GVC3200/GVC3202 Firmware Release Note

FIRMWARE VERSION 1.0.3.8

GVC3200, GVC3202

10/07/2016

IPv6 SUPPORT

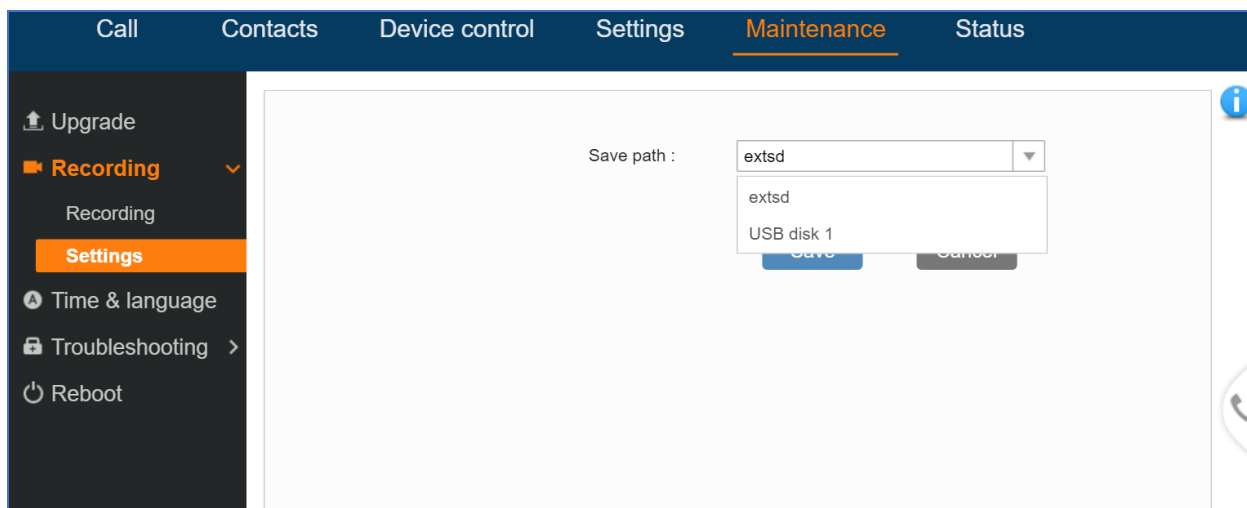
The GVC320x now supports both IPv4 and IPv6. The IPv6 setting is under GVC320x web UI->Settings->Network Settings, or GVC320x LCD->Settings->Network->Ethernet. Users can select prefer IPv4 or prefer IPv6. For IPv6, users can select “Auto-configured” or “Statically configured”.

- To configure IPv6 address, DNS server 1, DNS server 2 and Preferred DNS server, enter the IPv6 address in the format of 2001:db8:1:2::3.
- To visit web UI, enter the IPv6 address in the format of [2001:db8:1:2::3] in web browser.
- To configure SIP address, enter the IPv6 address in the format of [2001:db8:1:2::3] for SIP server.

SEARCH RECORDING FILE

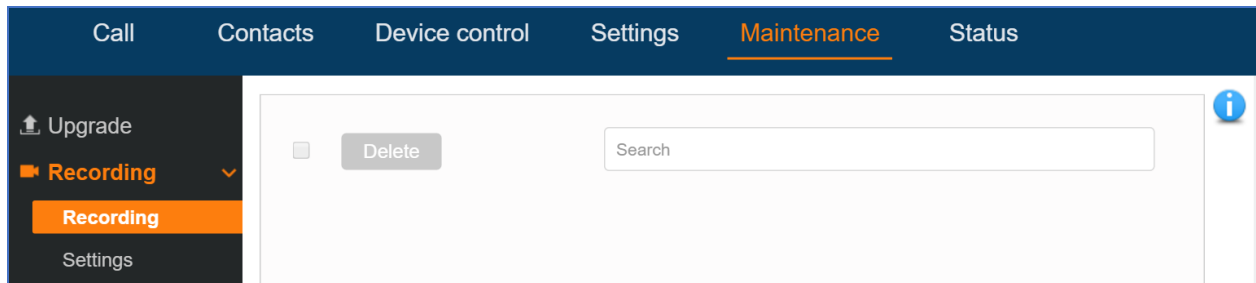
Under GVC320x web UI->Maintenance->Recording->Recording, in the “Search” field, enter the keyword to search for the available recording file.

CONFERENCE PRESET

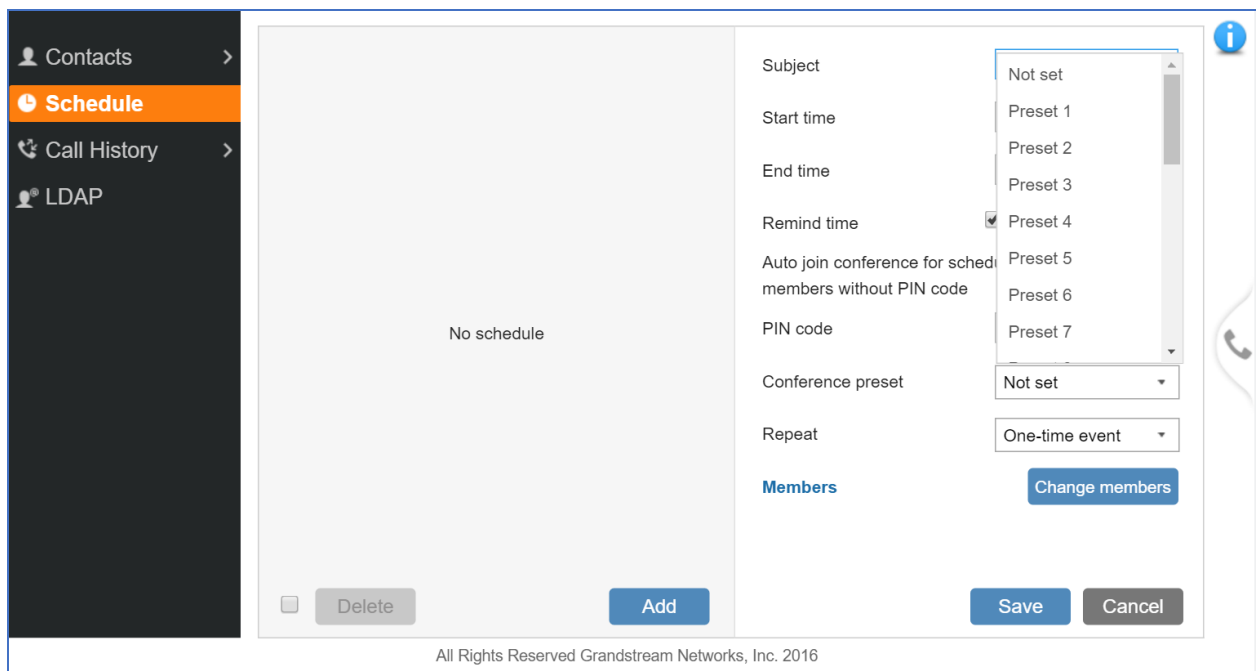
Under GVC320x web UI->Contacts->Schedule, when adding or editing a conference, there is an option “Conference Preset” for users to select a camera preset. When the scheduled conference starts, the GVC320x’s camera will be automatically placed to the preset position.

This option is also available in GVC320x LCD->Schedule when adding or editing a conference. Click on “Custom” in below figure and you will be redirected to preset setting interface to configure preset and make selection.

INTERFACE DETECTION IN SETUP WIZARD

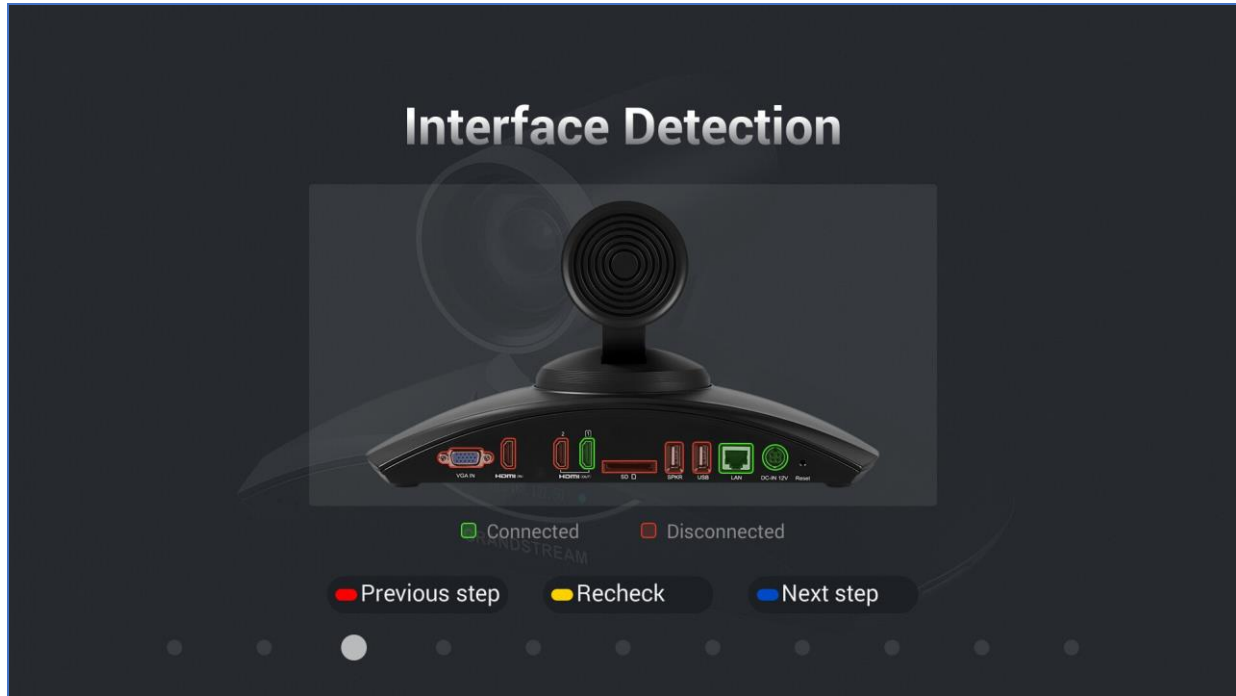
In the GVC320x setup wizard, an interface detection is available for users to check the interface connection status. The setup wizard can also be accessed from GVC320x->LCD->Applications->Setup Wizard.

AUTO MUTE ON ENTRY

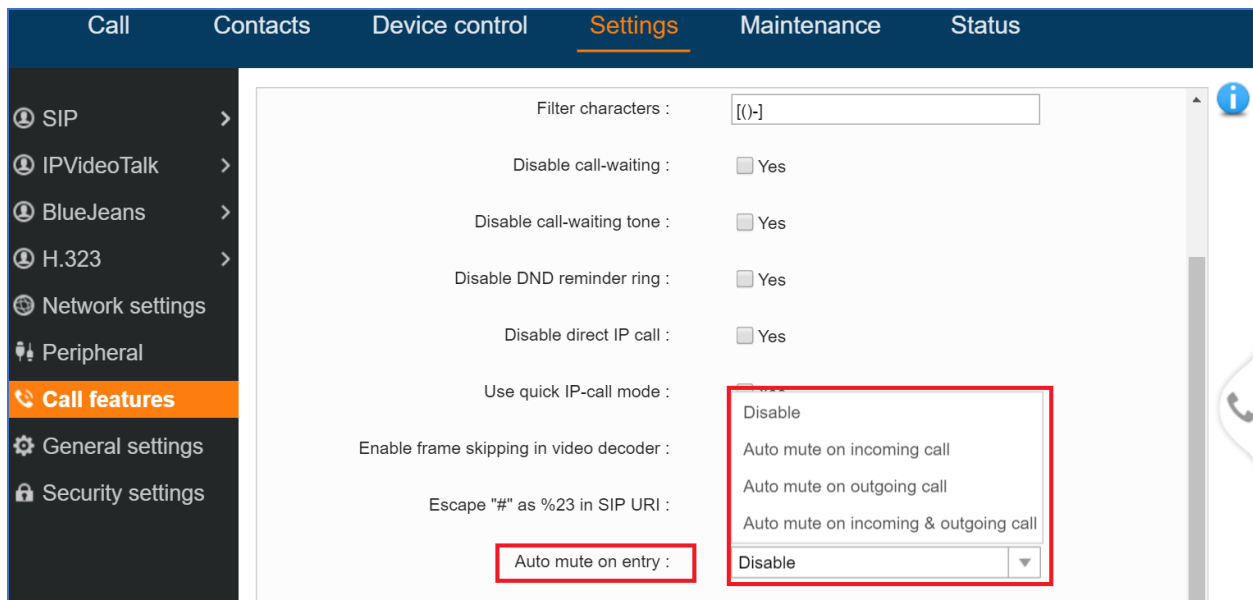
On GVC320x web UI->Settings->Call Features, option "Auto mute on entry" allows users to select whether to enable MUTE on incoming call or outgoing call. If enabled, the GVC320x will become automatically muted once the incoming call or outgoing call is established. The default setting is "Disable".

DHCP OPTION 132 AND DHCP OPTION 133

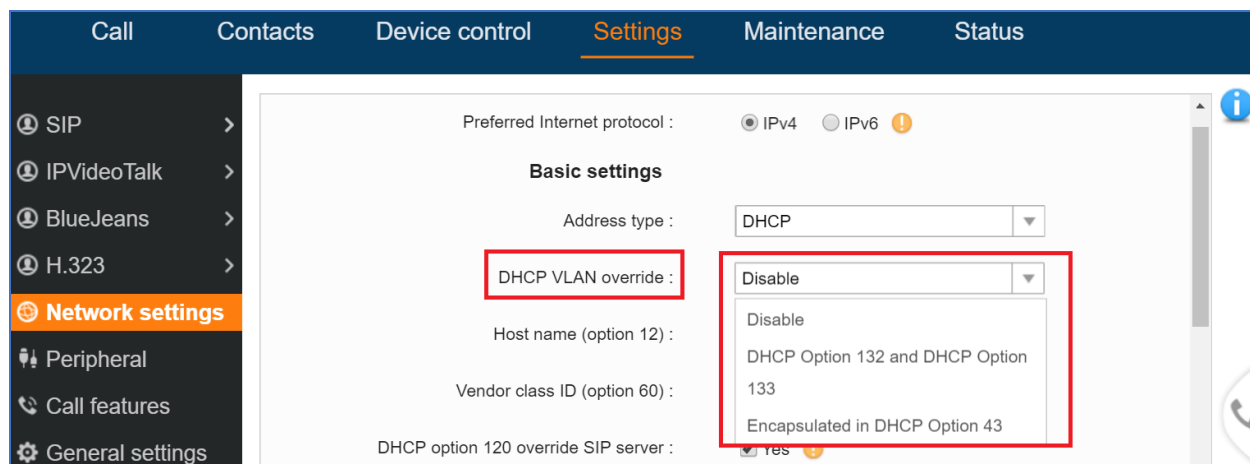
DHCP Option 132 defines VLAN ID and DHCP Option 133 defines priority tag ID. GVC320x supports DHCP VLAN override via DHCP Option 132 and DHCP Option 133, or encapsulated DHCP Option 132 and DHCP Option 133 in DHCP Option 43. This configuration is under GVC320x web UI->Settings->Network Settings: “DHCP VLAN override”.

Users could select “Disable”, “DHCP Option 132 and DHCP Option 133”, or “Encapsulated in DHCP Option 43”.

- When set to “DHCP Option 132 and DHCP Option 133”, the GVC320x will get DHCP Option 132 as VLAN ID and get DHCP Option 133 as VLAN priority, from the DHCP server directly.
- When set to “Encapsulated in DHCP Option 43”, the GVC320x will get VLAN ID and VLAN priority value from the DHCP Option 43 which has DHCP Option 132 and DHCP Option 133 encapsulated. In this case, please make sure the option “Allow DHCP Option 43 and Option 66 to Override Server” is enabled under GVC320x webUI->Maintenance->Upgrade.
- The default setting is “Encapsulated in DHCP Option 43”.

VIDEO PACKETIZATION MODE

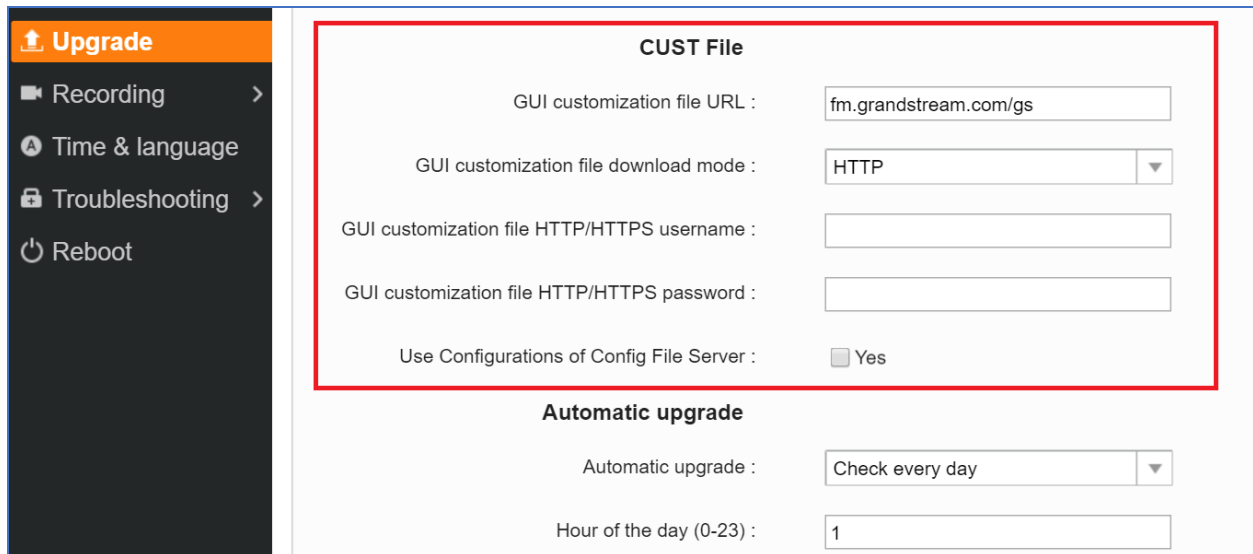
In GVC320x web UI, users can configure video packetization mode for SIP account and BlueJeans account. The packetization mode can be configured to 0, 1 or Auto. When it's set to 0 or 1, the INVITE will include packetization mode value as 0 or 1. If it's set to Auto, the INVITE will include both 0 and 1, and the packetization mode value is a result of negotiation between the endpoint and the server. Default setting is 1.

Packetization-mode for SIP account. 0 - 0, 1 - 1, 2 - Auto. Default is 1

Packetization-mode for BlueJeans account. 0 - 0, 1 - 1, 2 - Auto. Default is 1

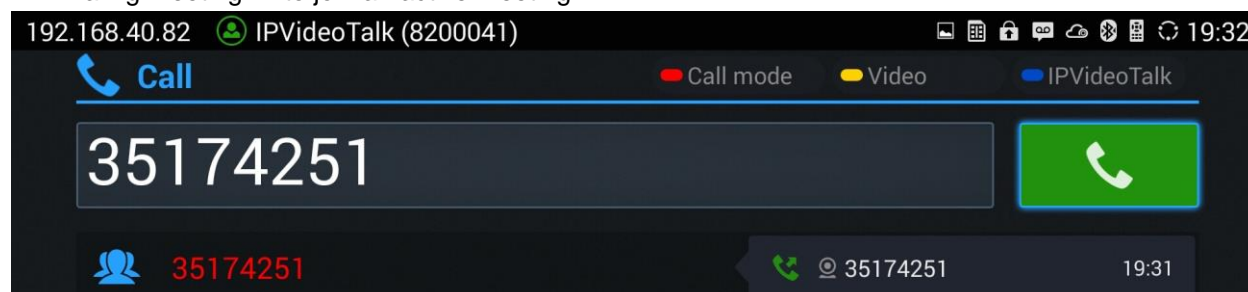
Added support to join IPVideoTalk meeting by dialing host GVC320x's IPVideoTalk ID or meeting ID. Please note only after meeting starts, GVC320x can use this method to join the conference as a participant.

- Dialing host GVC320x's IPVideoTalk ID to join an active meeting

PLAN EXPIRATION NOTICE

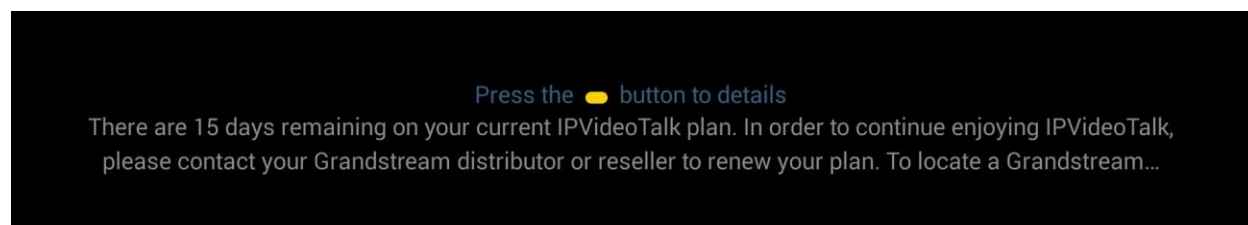
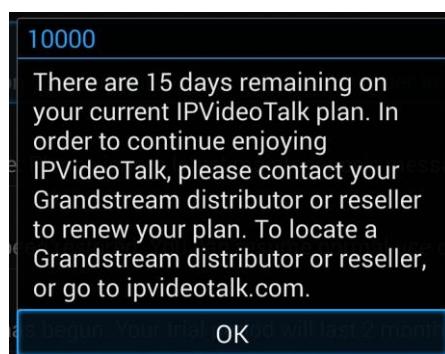
Added prompt message for current IPVideoTalk plan is about to expire or already expired on the bottom of GVC320x LCD home screen. Press yellow short key to view message details.

Also, detailed information is on GVC320X LCD menu->Applications->IPVideoTalk application->Notices.

SPECIFIC BUSY RESPONSE

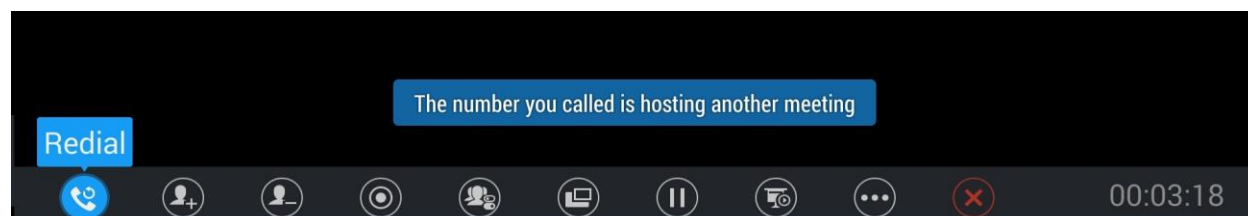
Added specific busy response messages rather than SIP 486 busy error prompt on IPVideoTalk dialing interface. Please note GVC320x can only join one IPVideoTalk meeting at one time.

- “The number you dialed is hosting another meeting”. Host GVC cannot be added as a participant of another IPVideoTalk meeting.

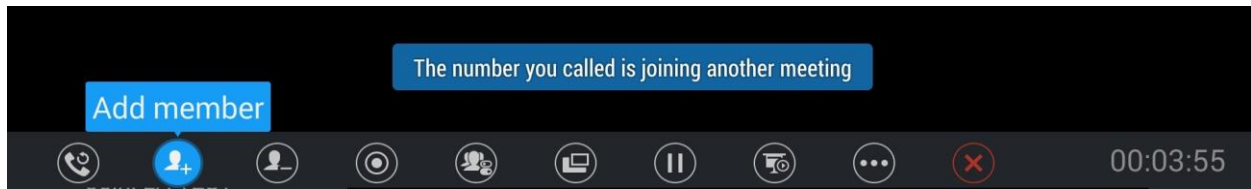
- “The number you dialed is joining another meeting”. Participant GVC of an active IPVideoTalk meeting cannot be added to another meeting.

MANUALLY START IPVIDEOTALK TIP

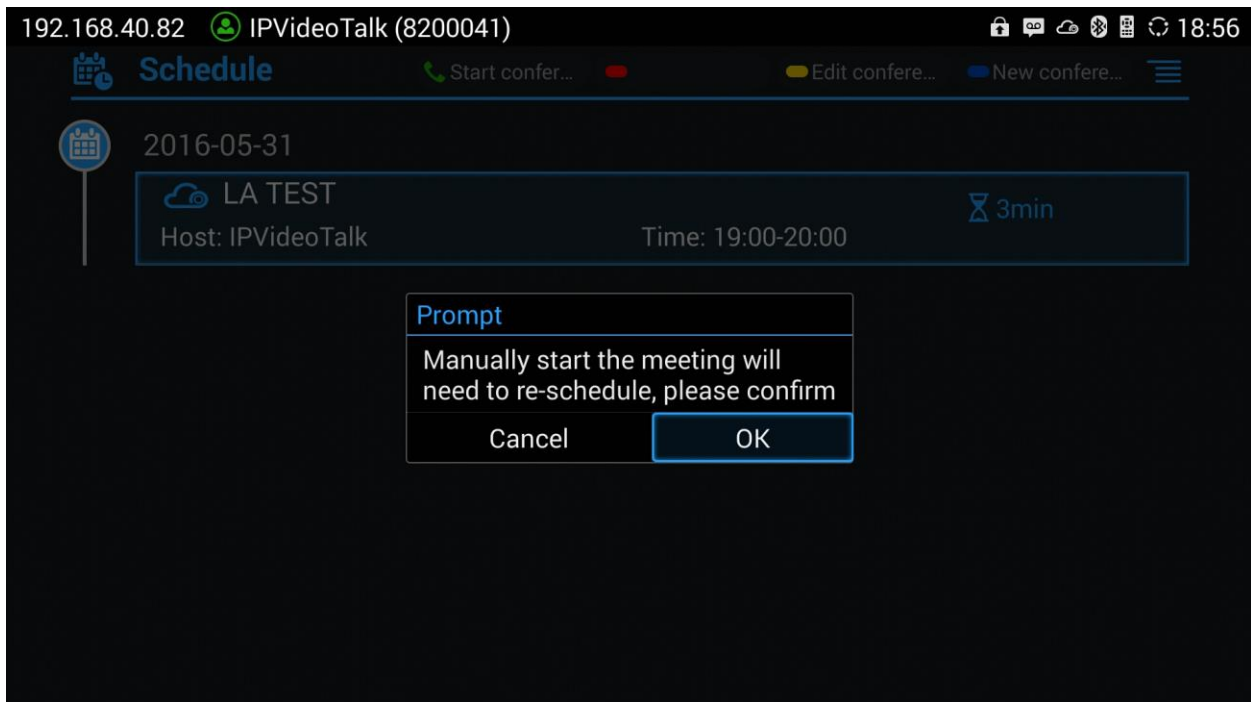
Schedule a meeting from IPVieoTalk Web Portal, then the meeting will sync to host GVC320x device LCD -> Schedule interface. There will be a prompt message “Manually start the meeting will need to re-schedule, please confirm” when pressing CALL button on remoter to start the meeting manually before or after scheduled time.
